ADDENDUM NO. A

PROJECT NAME: Outdoor Adventure Center
UNL PROJECT NUMBER: C220P001
RFP# 909495-12
CONSULTANT: RDG Planning & Design
ADDRESS: 900 Farnam on the Mall, Suite 100, Omaha, NE 68102
DATE OF ISSUANCE: November 7, 2012
DATE OF BID OPENING: November 15, 2012

The bid documents dated October 8, 2012, for the above referenced project are amended by this addendum.

DATE 11/7/12
MODIFICATION: ADD. A
REF'D SHEET: C1.1
REF'D DETAIL: -

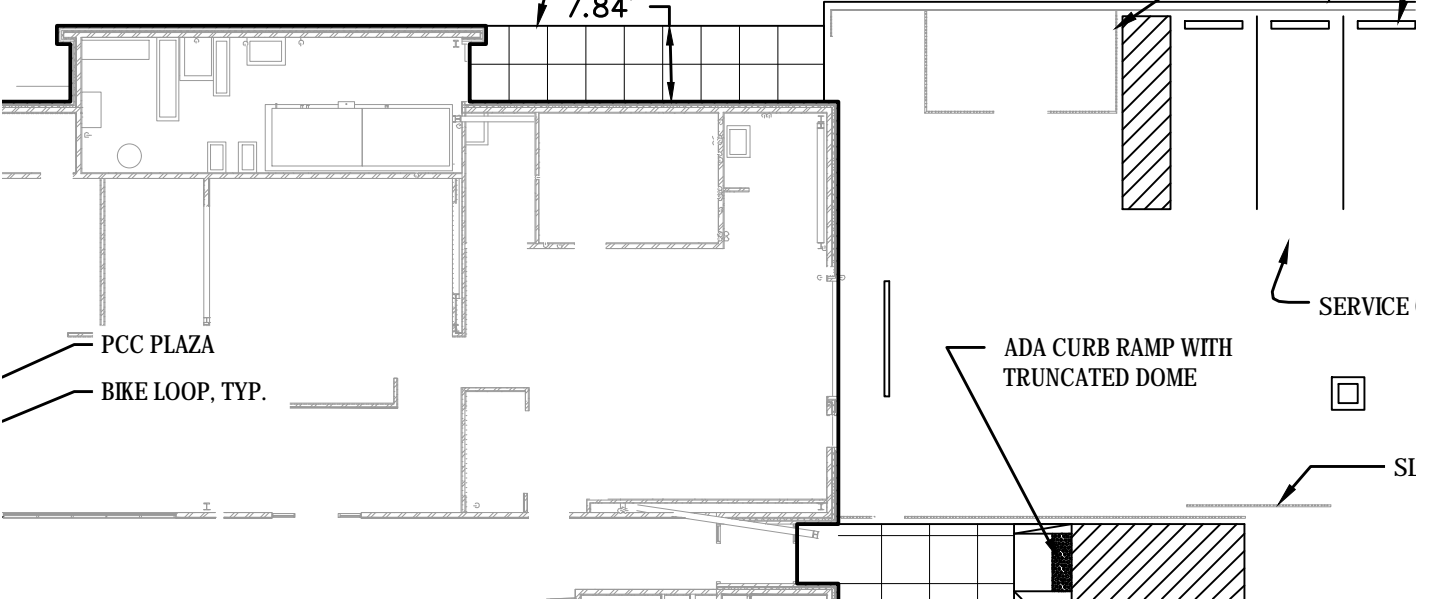
- A. Delete electric car/charging stations reference. Remove signs associated with these parking stalls.
- B. Delete three posts identified east of the bike lockers in the sidewalk. These were previously identifying posts for an overhang.
- C. Pea gravel is to be 12"-16" deep. Refer to Sheet C3.3 for detail to slope the subgrade towards the drain tile.
- D. Delete Note 11.1.
- E. Delete border and bollards around transformer. Coordinate with Electrical Site Plan for pad size and specifications. Refer to attached Supplemental Drawing SDC 001.
- F. Delete Brick Plaza Layout Plan.
- G. Revise limits of pea gravel to be located only within the area of the fall zone CIP wall (reference Detail 15/S7.02 for wall specifications). Top of wall to match architectural finish floor elevation at 100'-0". The radius of the CIP wall is 17'-8" measured at the centerline of the wall.

**10' SIDEWALK EXPANSION -
ALTERNATE 3 DETAIL**
SCALE: 1"=30'

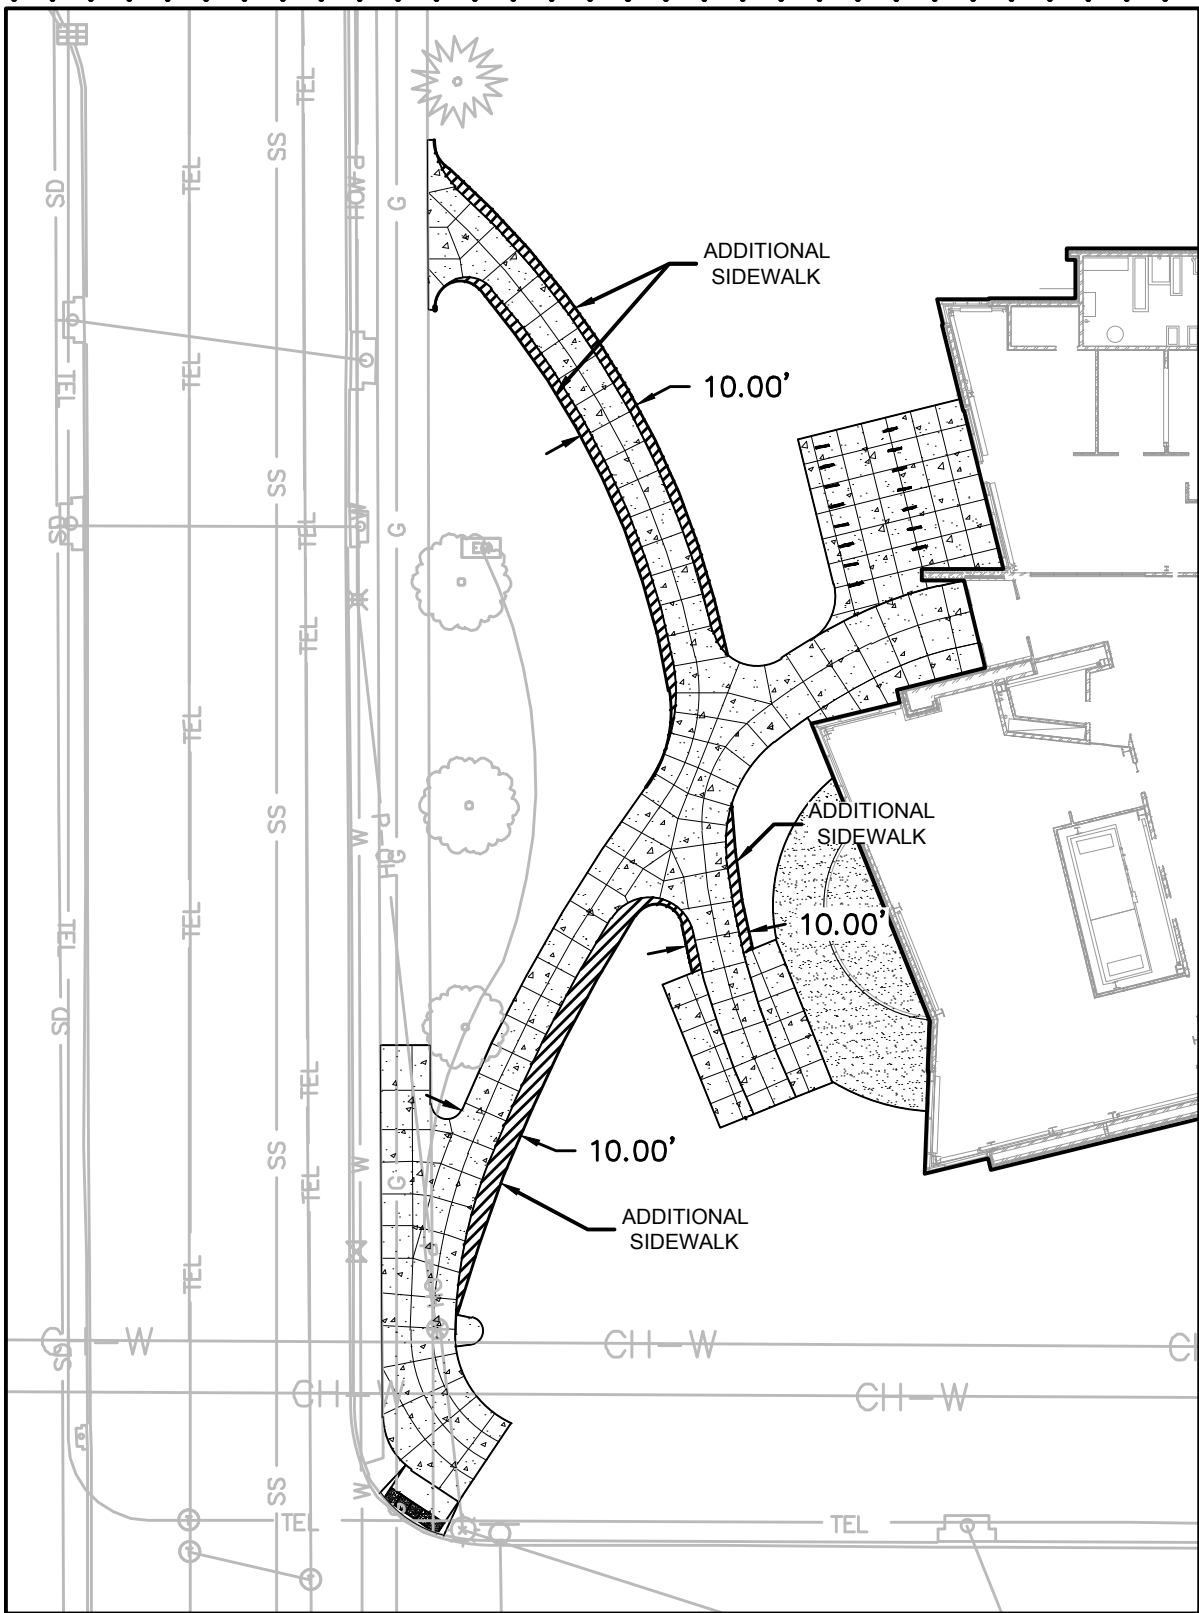
- E. Add Detail '10' SIDEWALK EXPANSION – ALTERNATE 3': Refer to attached Supplemental Drawing SDC 003 for detail to be added.
- F. Revise Welded Wire Mesh Note in Sidewalk Detail to read:

2011.182.00
45.02
SDA-001

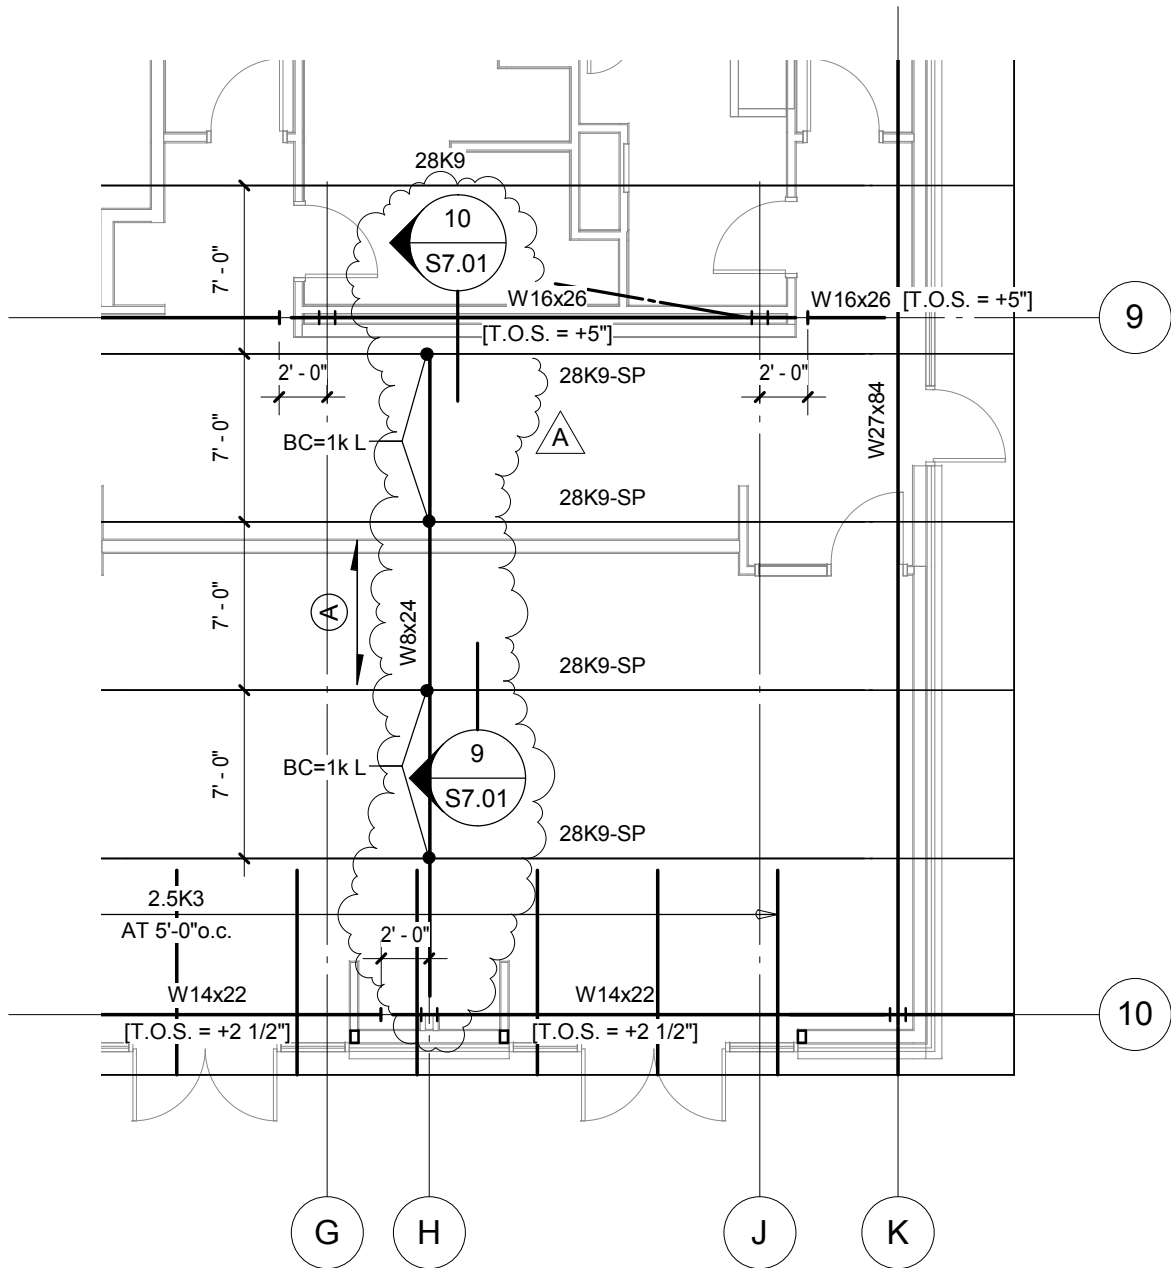
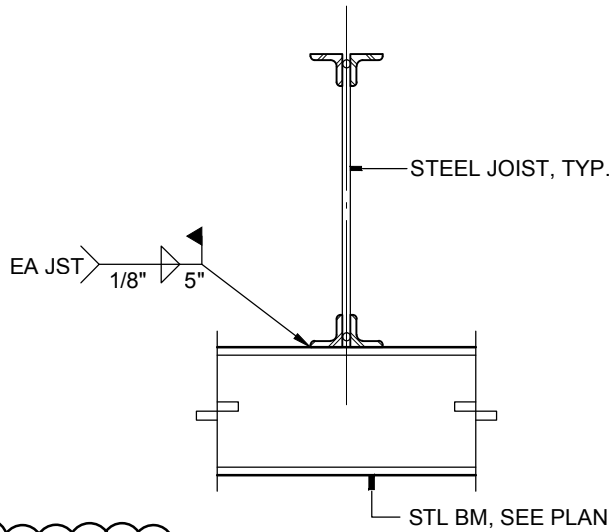
AGD-8 Sheet A10.01: Replace Door Schedule with attached Supplemental Drawing SDA-001.

9 **OPERABLE WALL BM**
1" = 1'-0"

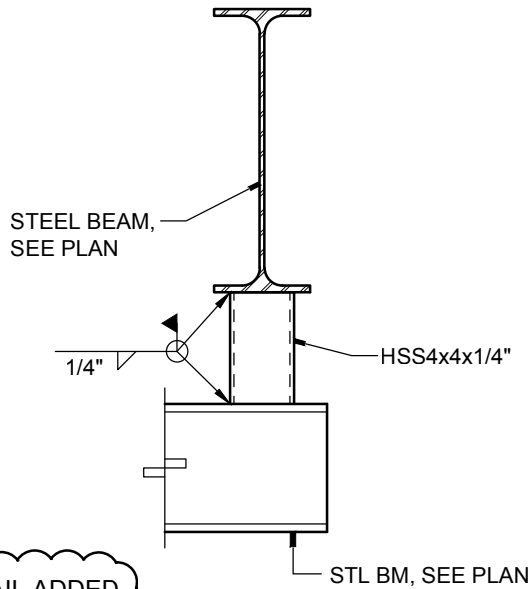
ASD-3 Sheet S7.01: Add Sections 9 and 10 per attached Supplemental Drawing SDS-002.

FIRST LEVEL FLOOR PLAN - HVAC

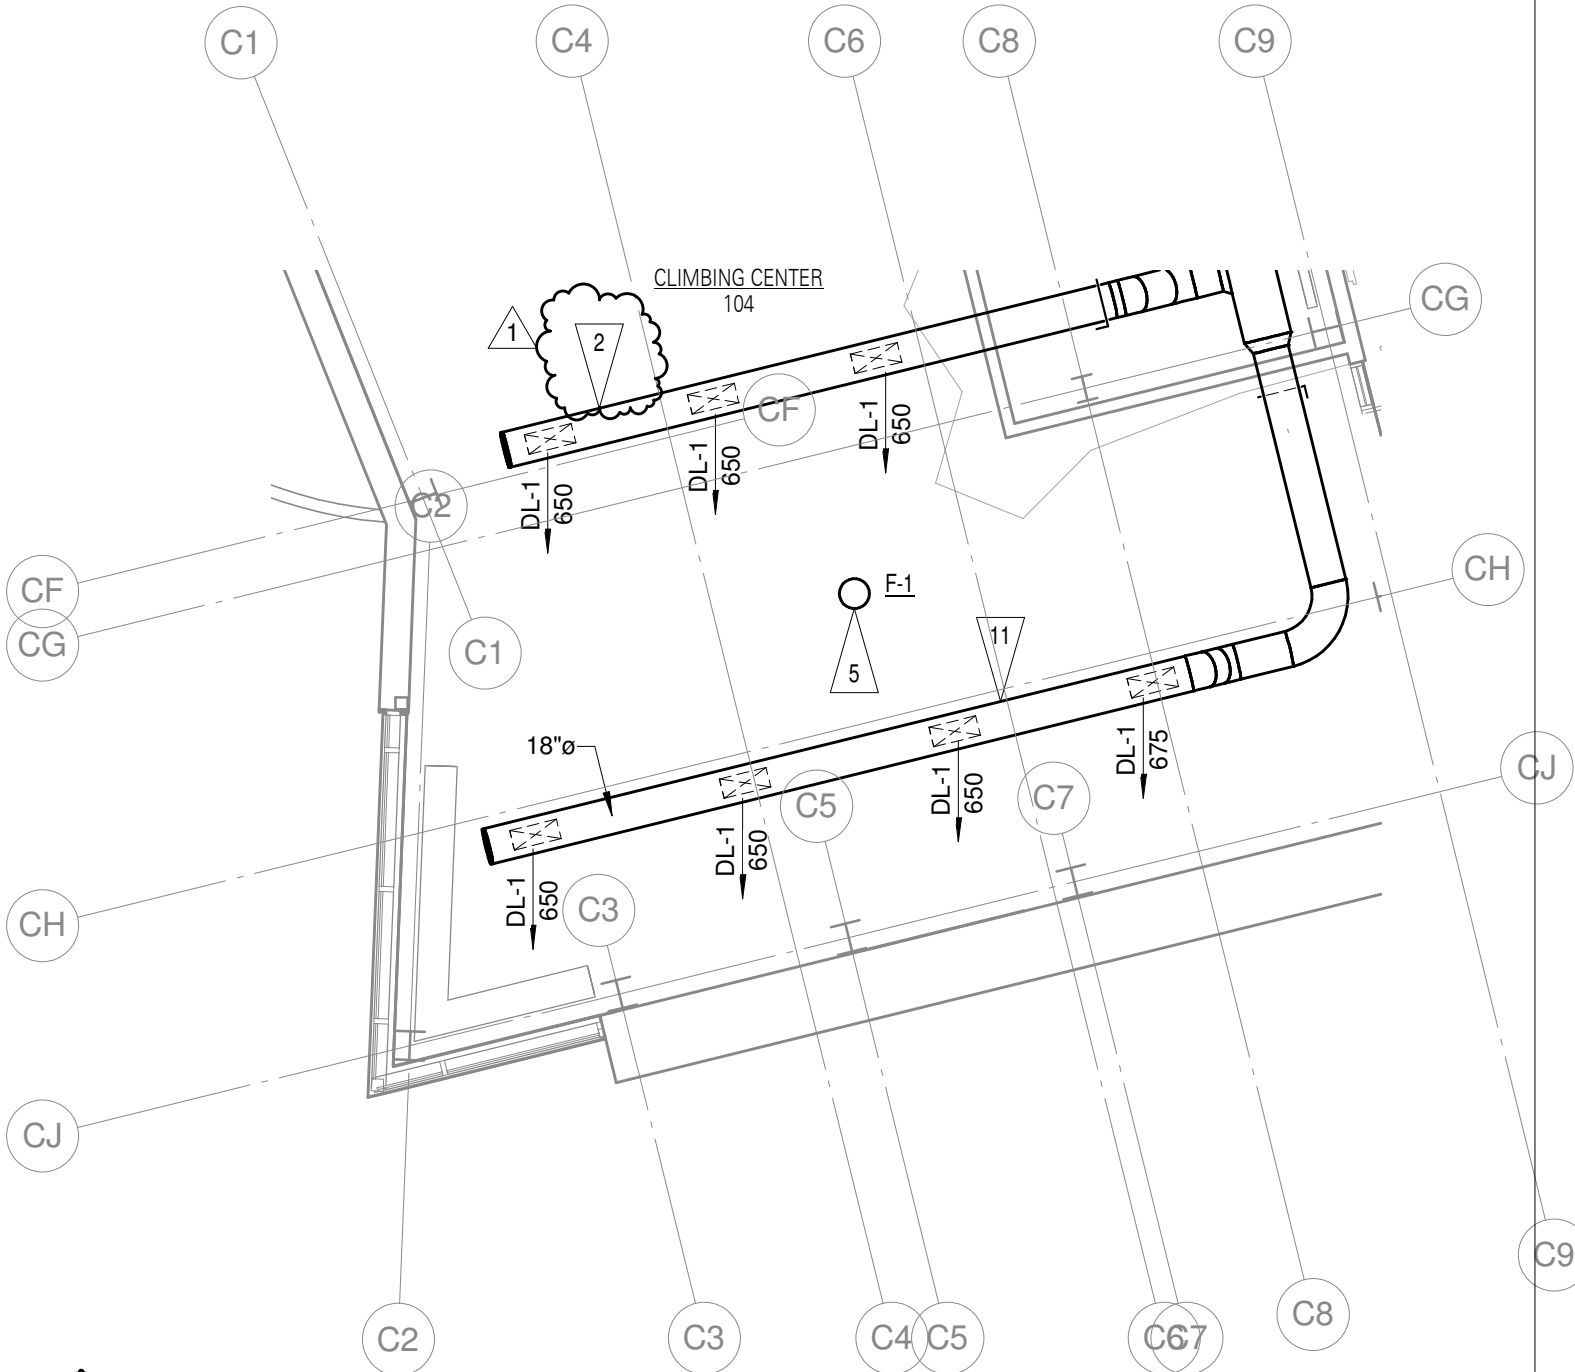
AMD-1 Sheet M1.1: Modify Flag Note 2 and add it in the Climbing Center 104. See attached Supplemental Drawing SDM-001.

- 1 INTERLOCK DAMPER TO CLOSE WHEN EXTERIOR DOOR INTO ROOM IS OPEN.
- 2 EXPOSED DUCTWORK IN CLIMBING CENTER, WORKROOM AND MAINTENANCE AREA TO BE DOUBLE WALL ROUND, INSULATED TYPE.

SITE PLAN - ELECTRICAL ADDENDUM A

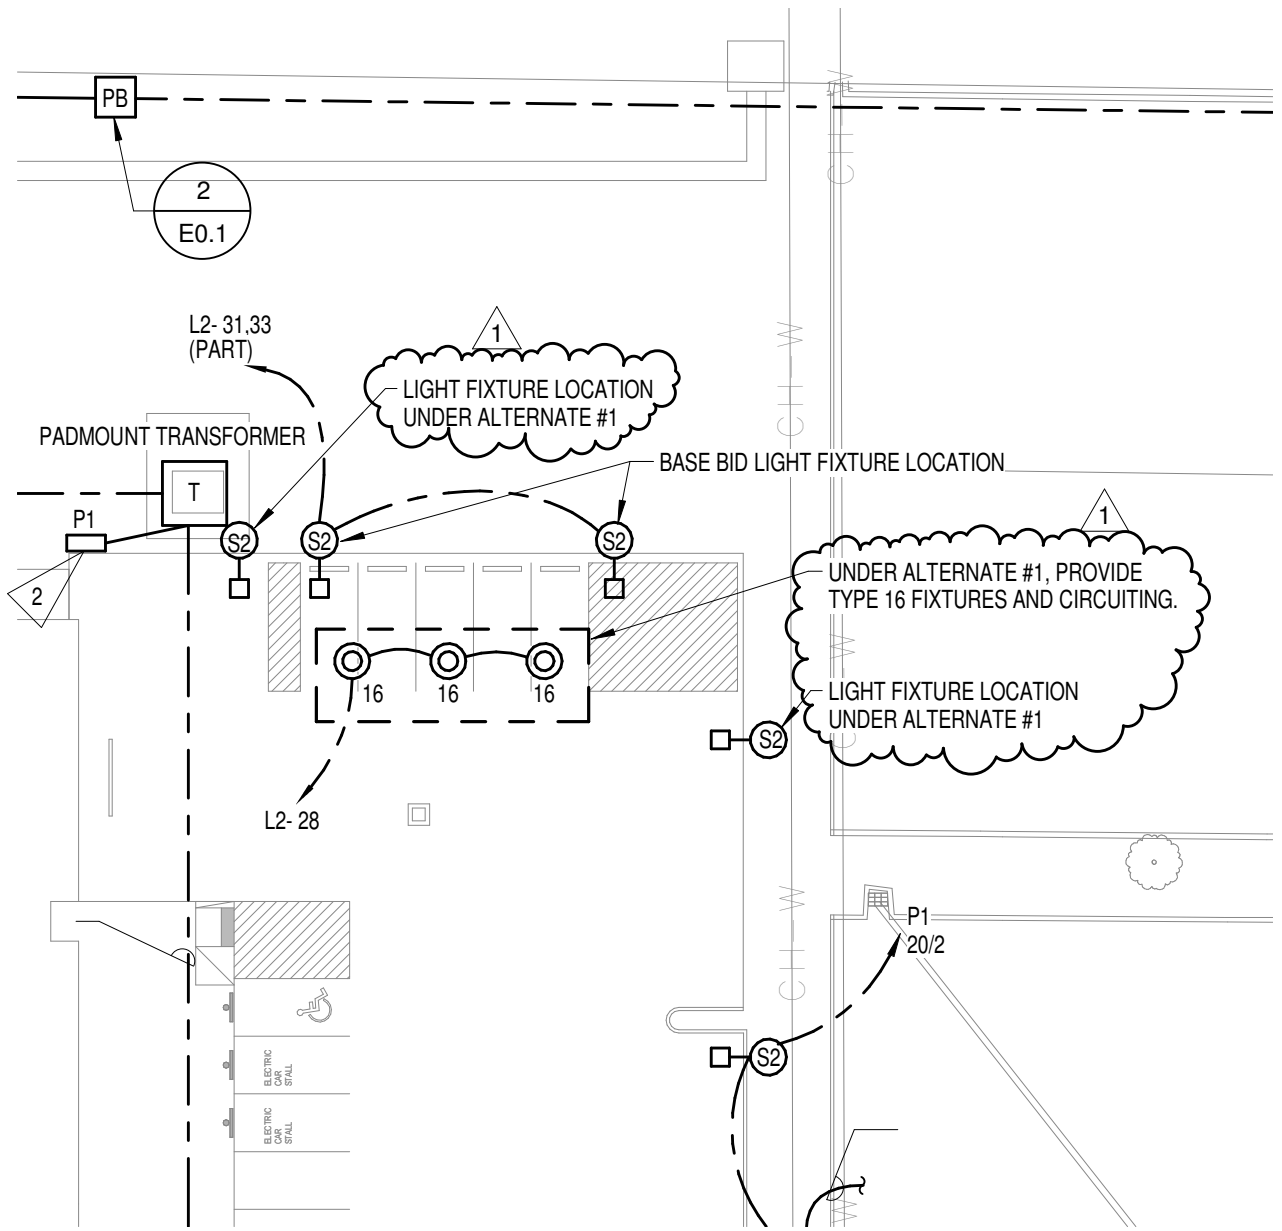
AED-1 Sheet E0.1: Clarify alternate number for courtyard site lighting. See attached Supplemental Drawing SDE-001.
